10/573,116

Office Action Summary	Application No. 10/573,116	Applicant(s) HUHSE ET AL.	
	Examiner SAMUEL A. TURNER	Art Unit 2877

DETAILED ACTION

FIG. -1

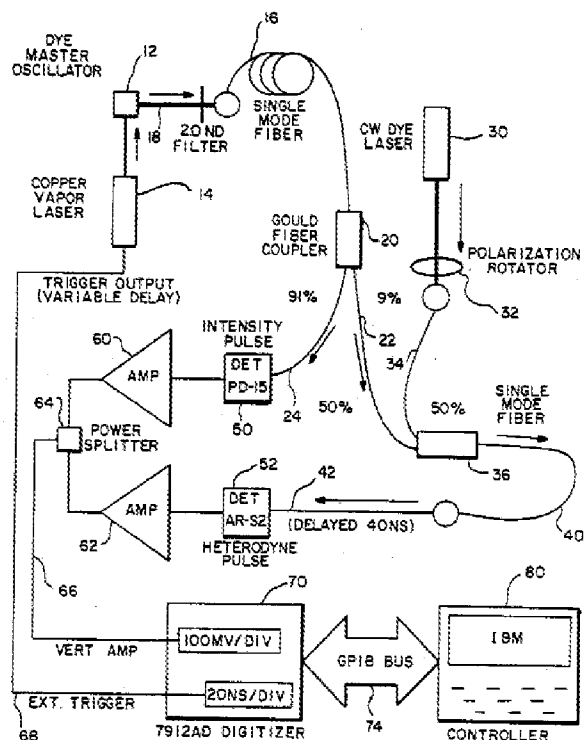
Claim 21 is rejected under 35 U.S.C. 102(b) as being clearly anticipated by Wyeth et al(4,940,331).

With regard to claim 21, Wyeth et al teach an arrangement(**Fig. 1**) having a pulsed laser(**Fig. 1; 12, 14**), an electrooptical component(**Fig. 1, 30**) and a measuring device(**Fig. 1; 50, 52**) having an evaluation device(**Fig. 1, 80**). The computer 80 would have been suitable for carrying out any processing method.
